Appendix Ia of RNTPC
Paper No. A/YL-KTN/1206

寄件者: Tang Lok San <[REDACTED]>
寄件日期: 2026年02月27日星期五 0:30
收件者: tpbpd/PLAND
副本: David Chi Chiu CHENG/PLAND; Athena Pui Yin LAI/PLAND
主旨: Re: S. 16 Planning Application No. A/YL-KTN/1206 - Departmental Comments
附件: AYL-KTN 1206 20260227.pdf
類別: Internet Email

有關規劃署對 A/YL-KTN/1206 的查詢

Proposed Temporary Warehouse (excluding
 Dangerous Goods Godown) with Ancillary
 Facilities and Associated Filling of Land
 for a Period of 3 Years

Proposed Layout Plan

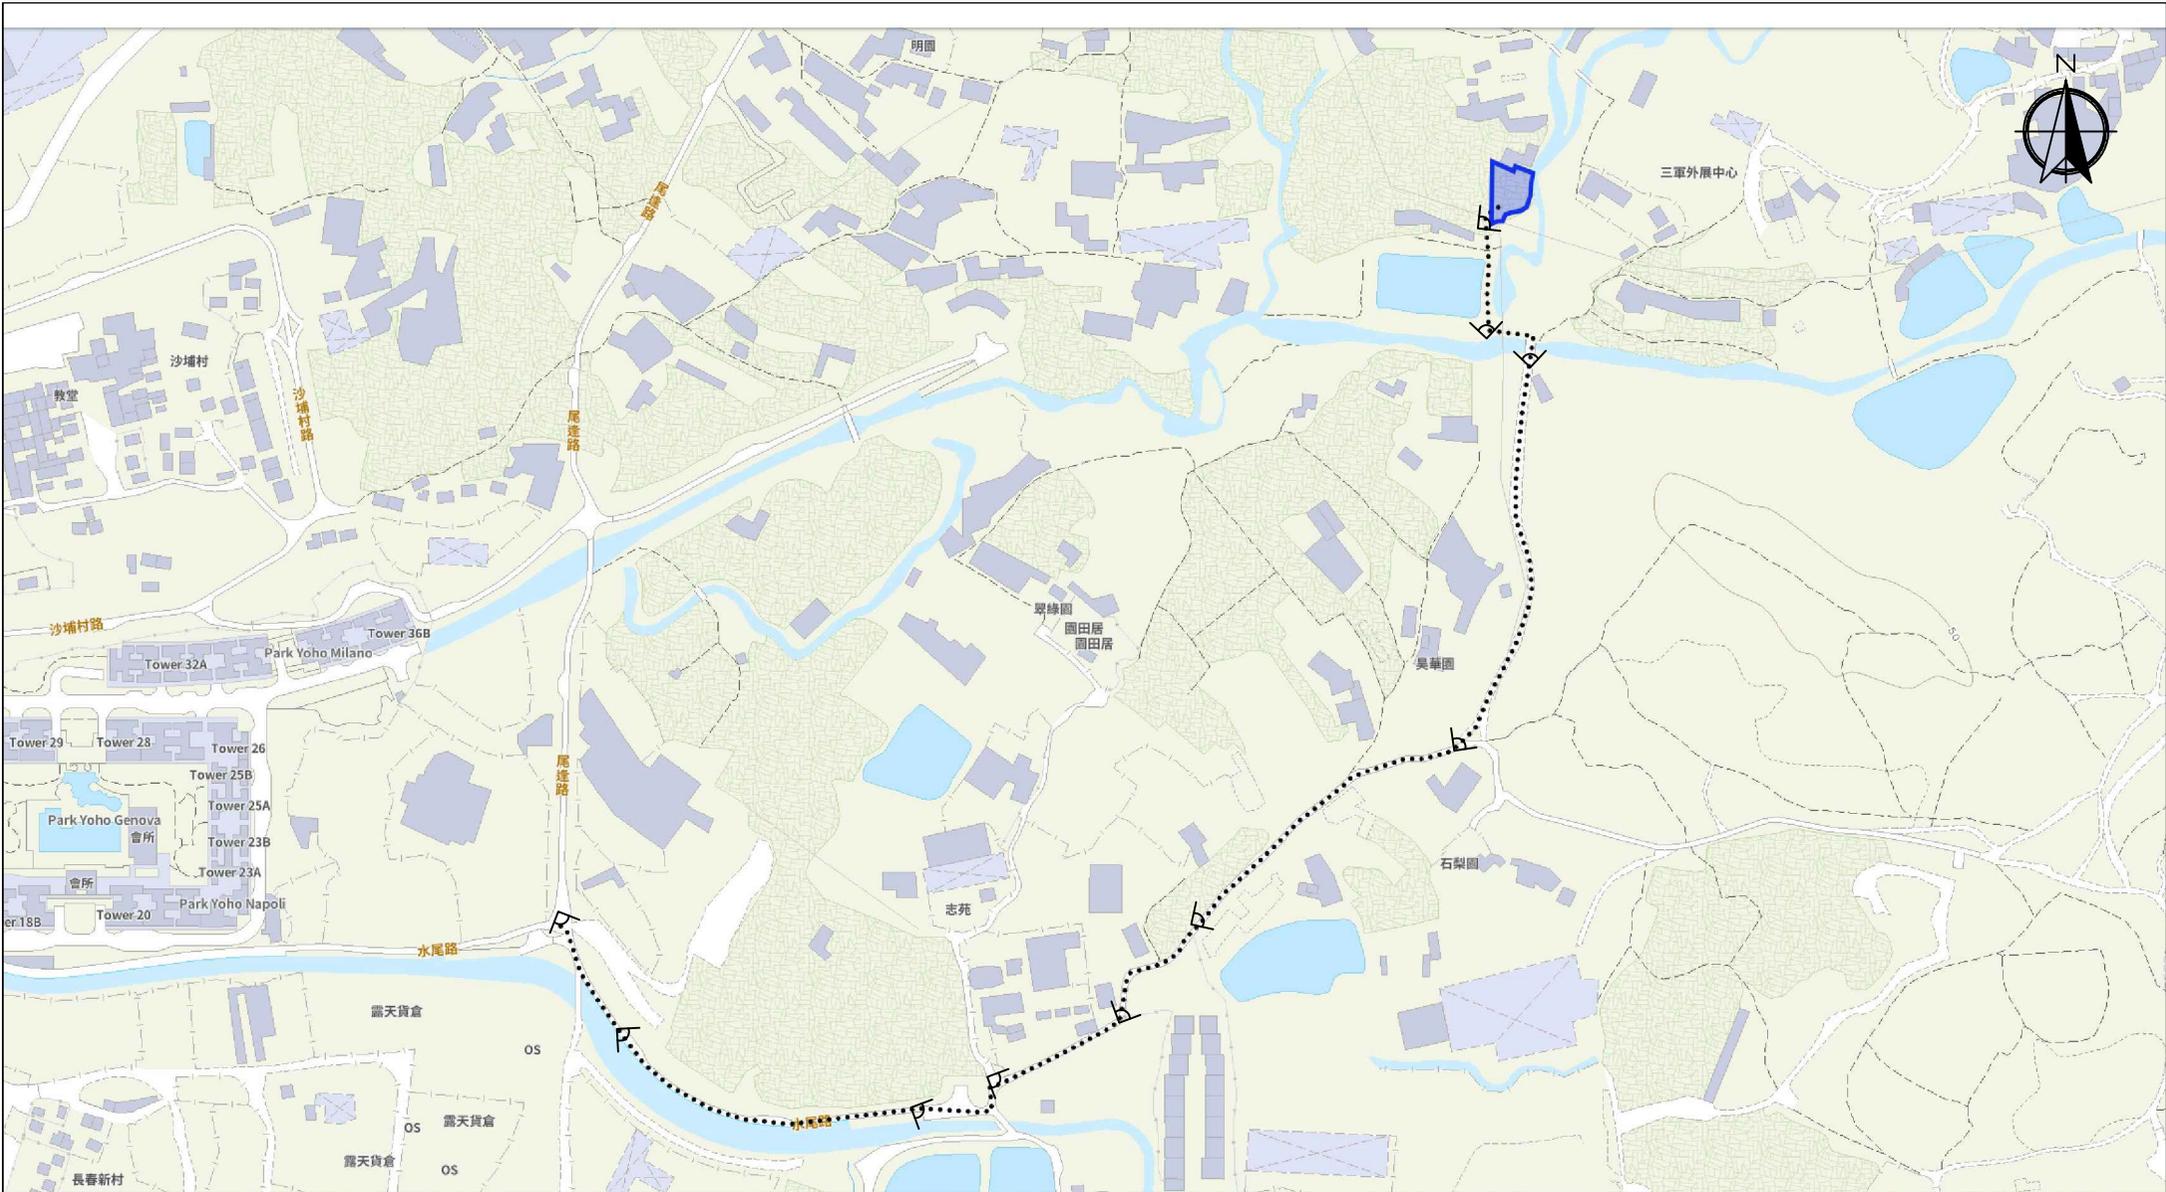
申請構築物方面，申請人會在申請獲批後根據已提供的擬議佈局平面圖進行發展，並會修正建築物的位置。請參考 Appendix 2。

在申請地點內有一個直徑超過 10 米的圓形空間，足夠讓車輛進行調遣的動作，進入本申請地點的車輛不會在公用道路上讓車輛等候進入本申請地點，停泊在公用道路及以倒後形式進出本申請地點。參考文件末端的 Appendix 2。

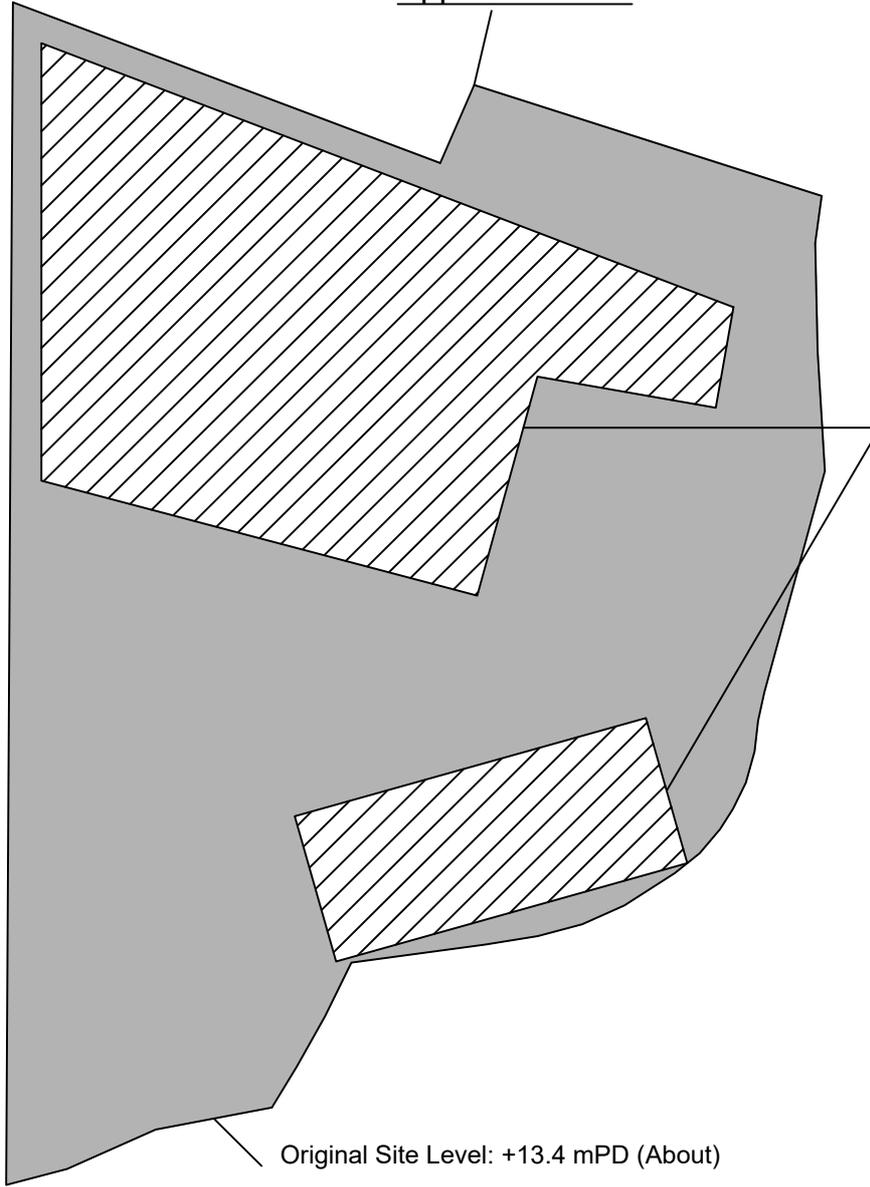
申請地點有道路連接，前往本申請地點途經水尾路，再轉到郊區小徑到達申請地點。水尾路沿途道路約有 3-6 米闊，並具有避車處。私家車及客貨車有足夠的位置通過及進行調遣的動作。申請地點的出入口約 6 米闊。沿途道路相片請參考文件末端，而相片的觀看點請參考 Appendix 3。
